From: Pederson Ronda M (AREVA NP INC) [Ronda.Pederson@areva.com]
Sent: Thursday, April 30, 2009 6:14 PM
To: Getachew Tesfaye
Cc: BENNETT Kathy A (OFR) (AREVA NP INC); DELANO Karen V (AREVA NP INC); DUNCAN Leslie E (AREVA NP INC)
Subject: Response to U.S. EPR Design Certification Application RAI No. 64, Supplement 2
Attachments: RAI 64 Supplement 2 Response US EPR DC.pdf

Response to
Request for Additional Information No. 64, Supplement 2

U. S. EPR Standard Design Certification
AREVA NP Inc.
Docket No. 52-020
SRP Section: 05.03.01 - Reactor Vessel Materials
SRP Section: 05.03.02 - Pressure-Temperature Limits, Upper-Shelf Energy, and
Pressurized Thermal Shock
SRP Section: 05.03.03 - Reactor Vessel Integrity
Application Section: FSAR Ch. 5
CIB1 Branch

Question 05.03.02-5:

Figure 5.3-1—Reactor Coolant System Heatup Pressure-Temperature Curve

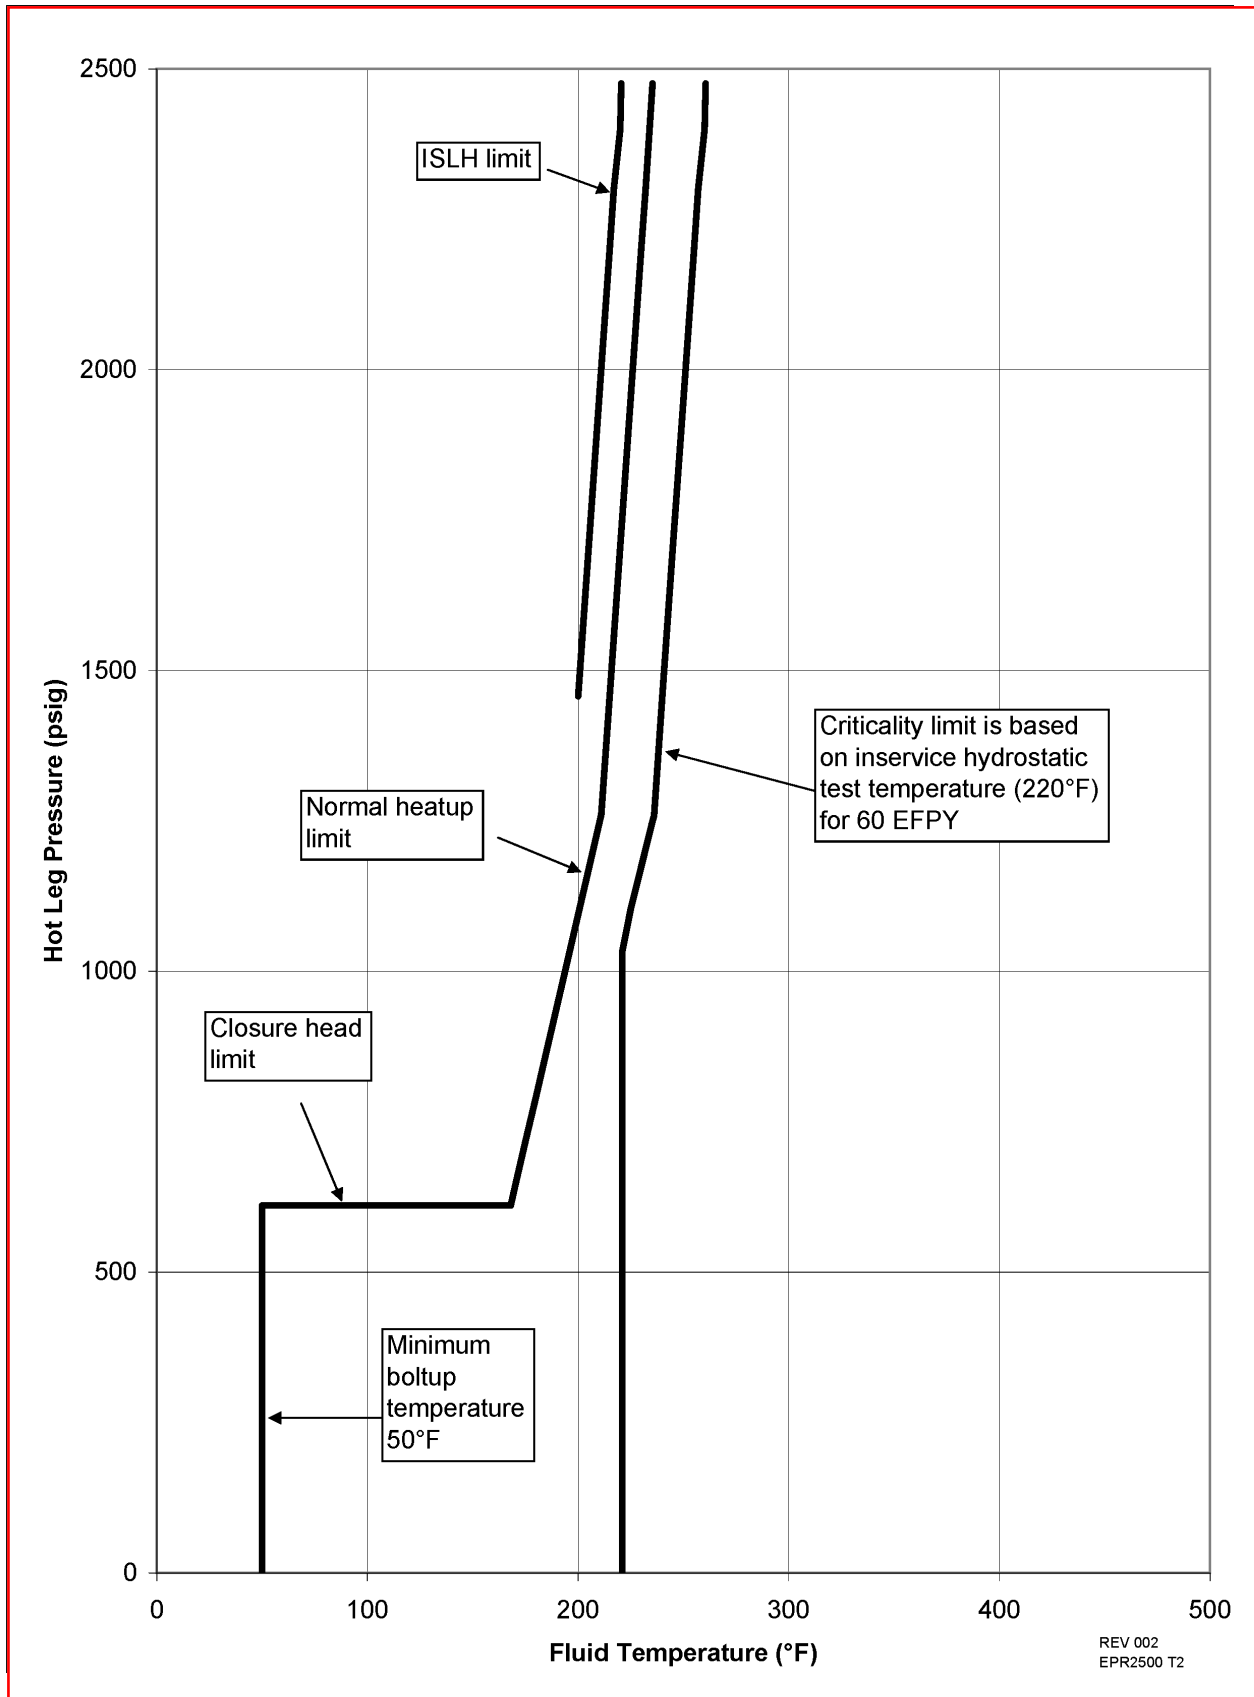
Section 5.3.2 of the FSAR states that the COL applicant will provide a plant-specific Pressure Temperature Limits Report (PTLR). To enhance the level of standardization in the certification information, it would appear appropriate to provide the PTLR at the design certification stage rather than in each COL application. Discuss your rationale for not including the PTLR in the FSAR. Also, discuss how the adequacy of Technical Specification requirements for pressure-temperature limits can be assured at the design certification stage if generic P-T limits or a PTLR is not provided at the design certification stage.

The P-T limit curves in U.S. EPR FSAR Tier 2, Figure 5.3-1 and Figure 5.3-2 will be replaced with new P-T limit curves. These curves contain additional information required by GL 96-03, and are consistent with the P-T limits in ANP-10283P, Revision 1.

Generic heatup and cooldown curves [for the U.S. EPR RPV design](#) are provided in Figure 5.3-1—Reactor Coolant System Heatup Pressure-Temperature Curve and Figure 5.3-2—Reactor Coolant System Cooldown Pressure-Temperature Curve, [and are based on limiting vessel material properties](#). A COL applicant that references the
